**GREENBRIER COUNTY BOARD OF EDUCATION
GREENBRIER COUNTY, WEST VIRGINIA**

**ALDERSON ELEMENTARY SCHOOL ADDITIONS AND RENOVATIONS
ADDENDUM #3
OCTOBER 12, 2022**

THRASHER PROJECT #060-10180

LAYOUT FILE: C:\Users\jmc\OneDrive\Documents\11_2022\ALDERSON ELEMENTARY-GREENBRIER COUNTY BOARD OF EDUCATION-DRAWINGS.DWG
 CAD FILE: C:\Users\jmc\OneDrive\Documents\11_2022\ALDERSON ELEMENTARY-GREENBRIER COUNTY BOARD OF EDUCATION-DRAWINGS.DWG
 USER: jmc

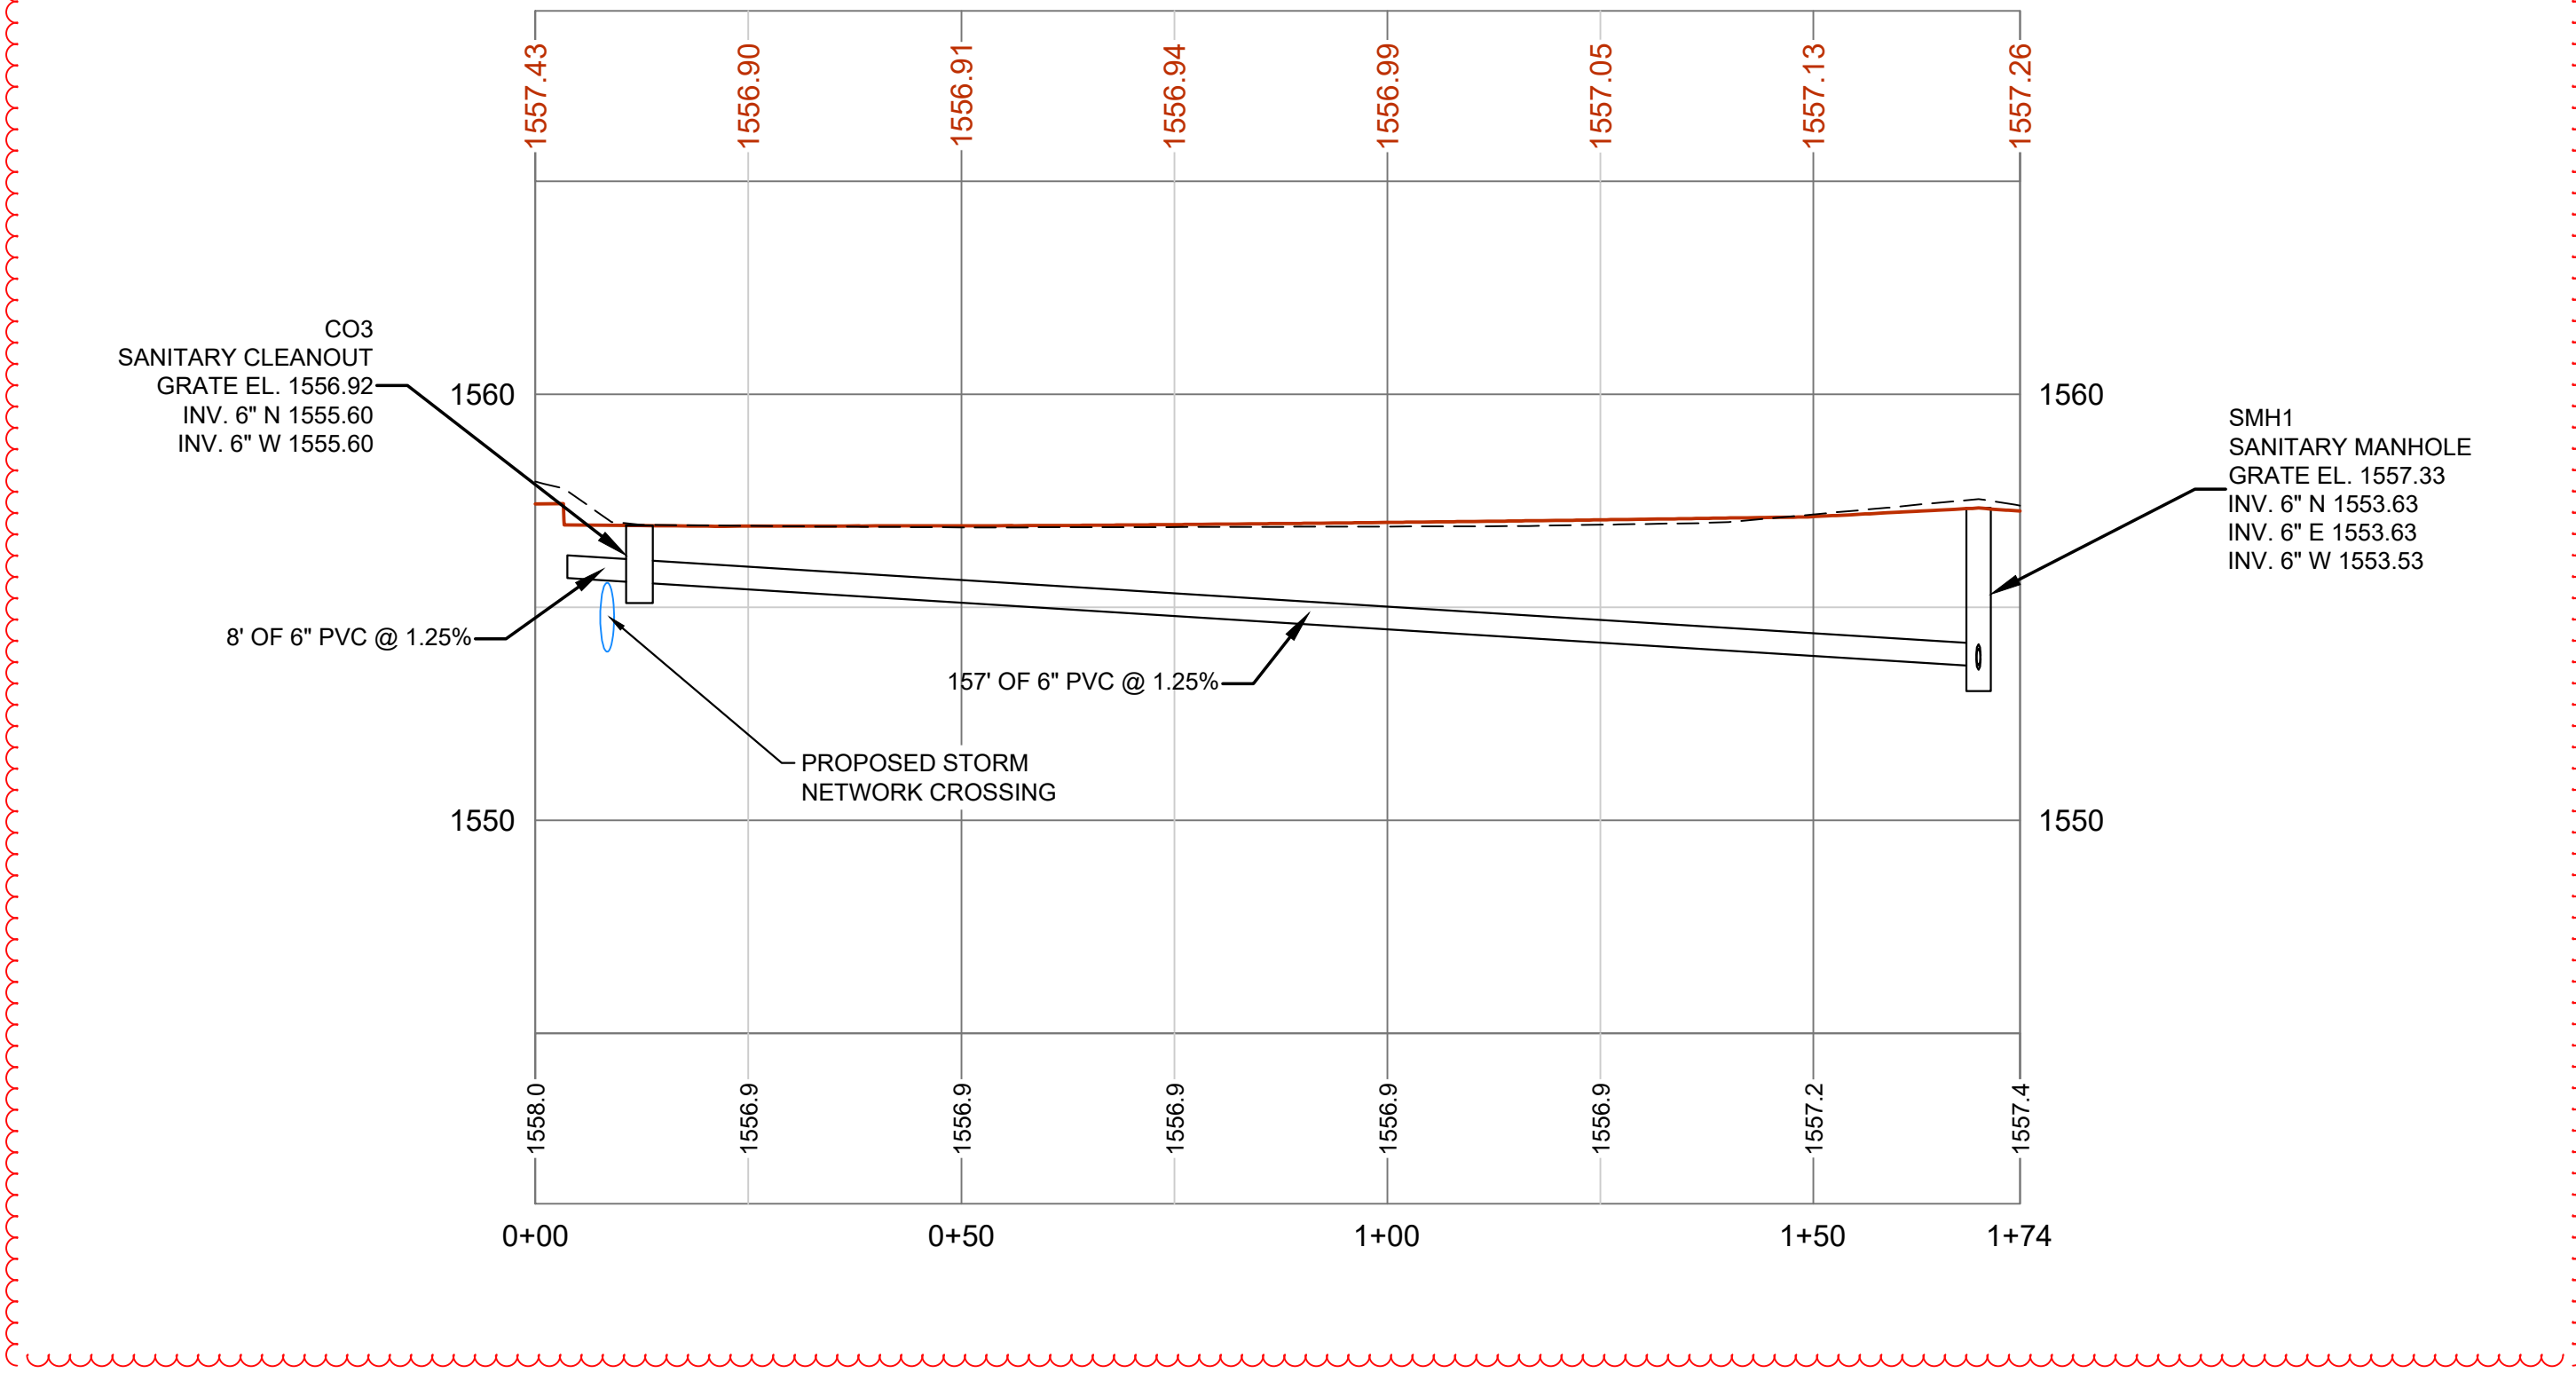
Sheet C1.10, REVISE flagged items on the updated sheet attached to this Addendum.

NO.	DATE	DESCRIPTION
1	10/06/2022	ADDITIONAL UNDERGROUND DETENTION, IDENTIFIED SEWAGE

1 COILING COUNTER DOOR DETAIL

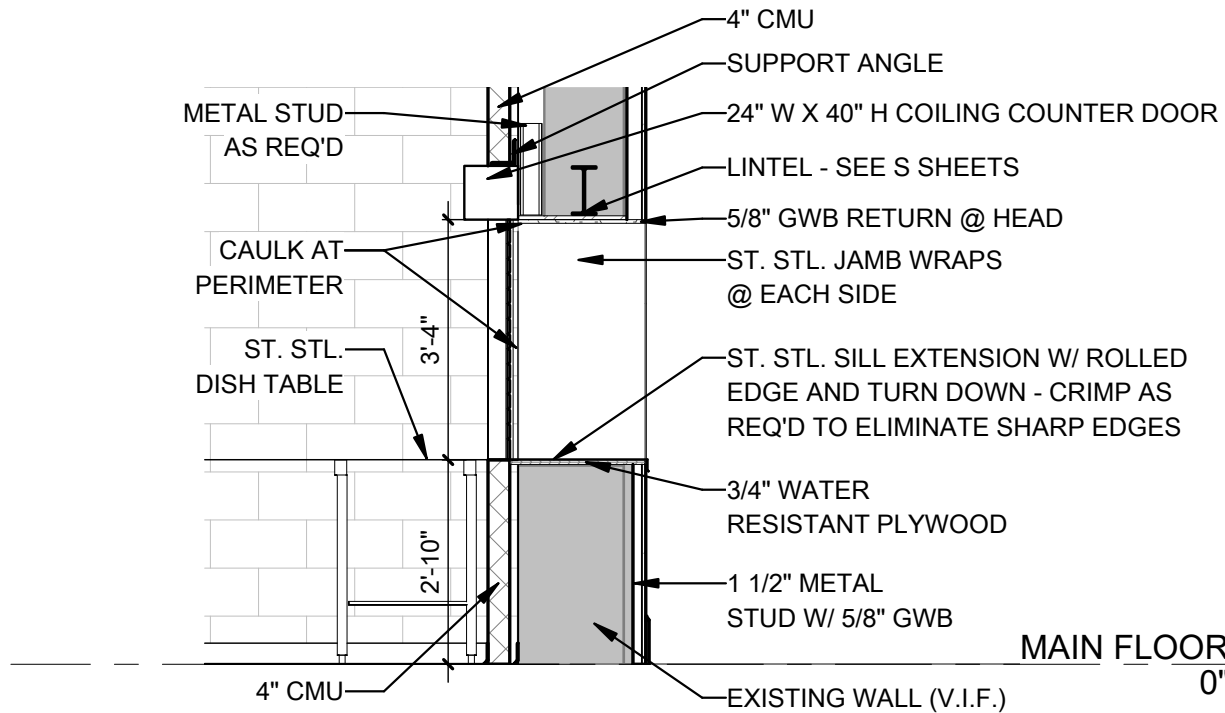
Sheet A4.06, ADD Detail 1/ADD3-1 for the Coiling Counter Door as attached to this Addendum.

Q1. Please confirm the opening size of the counter identified in Addendum 2, Q14, A14 (Elevation 7/A4/06, Note 8.)

A1. See supplemental Detail 1/ADD3-1 as attached to this Addendum.

TRASH COMPACTOR RISER

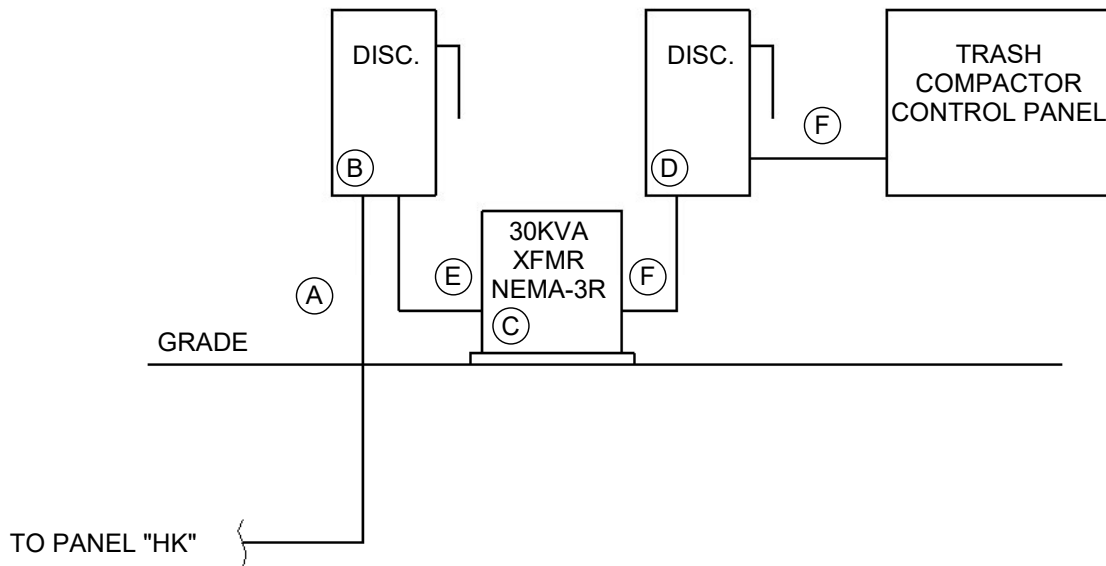
Sheet SE1.01 – ADD power for trash compactor located near dumpster as indicated on SK-E8 as attached to this Addendum.

- (A) PROVIDE 3P/50A BREAKER IN PANEL HK FOR TRASH COMPACTOR. USE 1" CONDUIT WIT (3)-#8, #10 GND.
- (B) 3P/60A, 480V, NEMA-3R FUSED DISCONNECT SWITCH. FUSED AT 50A.
- (C) 30KVA, 3-PHASE, DRY TYPE TRANSFORMER, NEMA 3R, 480V TO 120/240V.
- (D) 3P/100A, 240V, NEMA-3R FUSED DISCONNECT SWITCH. FUSED AT 80A.
- (E) 3/4" CONDUIT WIT (3)-#8, #10 GND.
- (F) 1 1/4" CONDUIT WITH (3)-#4, #8 GND.
